RFP #113163

ADDENDUM #1

The following information is provided for Bid #113163 for the Construction of the Falls Run Interceptor Sewer 95 Crossing Project for the Stafford County Department of Utilities. All prospective Bidders are hereby advised to make the changes to the Bid Documents in their possession as follows:

Plan Sheet 4 – Please add the following:

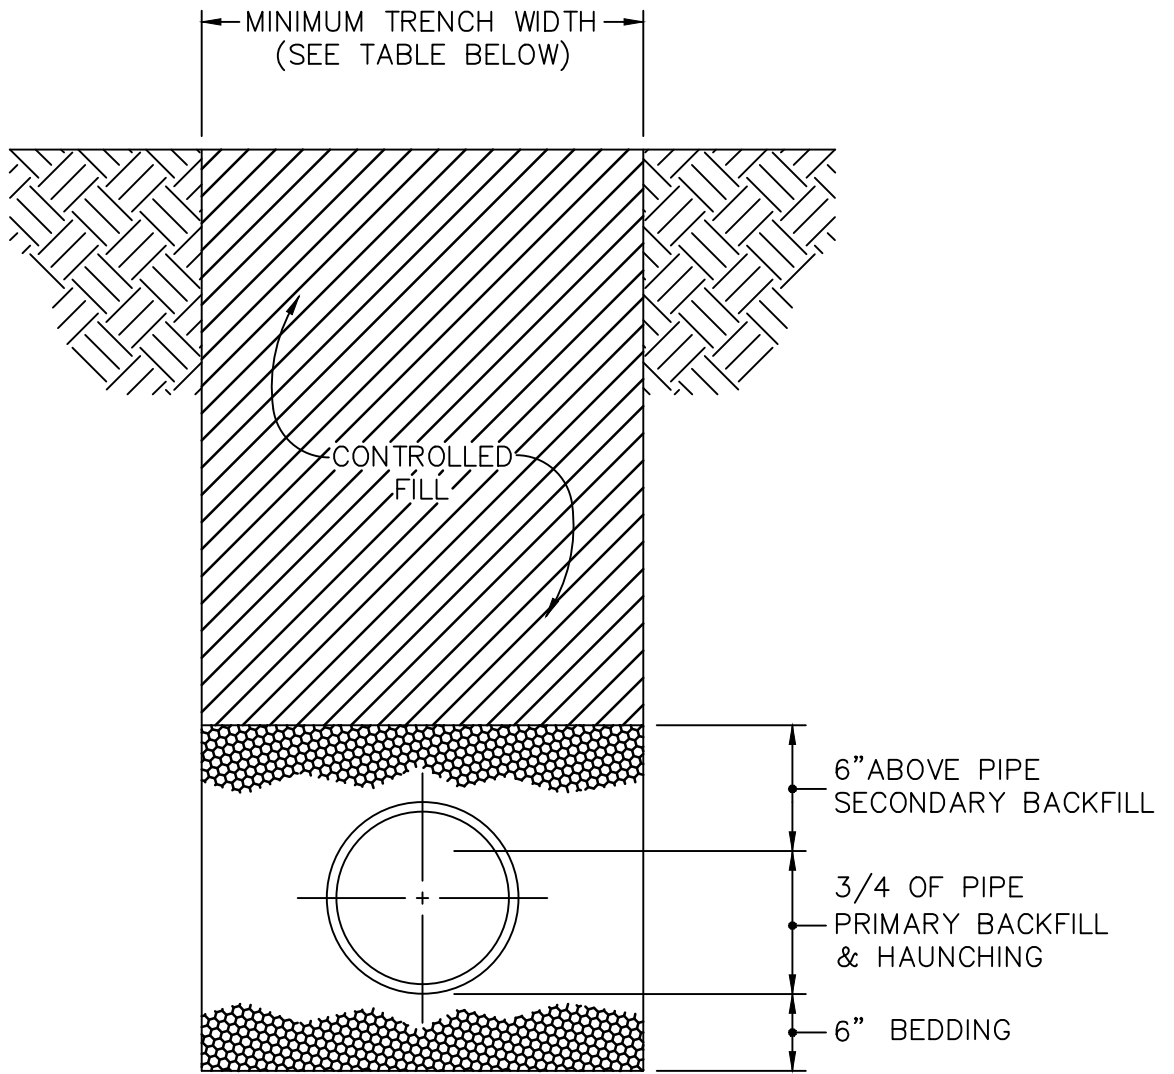
The contractor is not to install the 30” Gate Valve or the 15” Gate Valve as shown. The 15” Gate Valve is about 5’ east of Manhole 62 and the 30” Gate Valve is 5’ west of Manhole 58.

The size of Manhole 59 and Manhole 62 will increase from 84” to 96”.

Manhole 58 Shall have a Watertight Frame and Cover (including replacement of the vent)
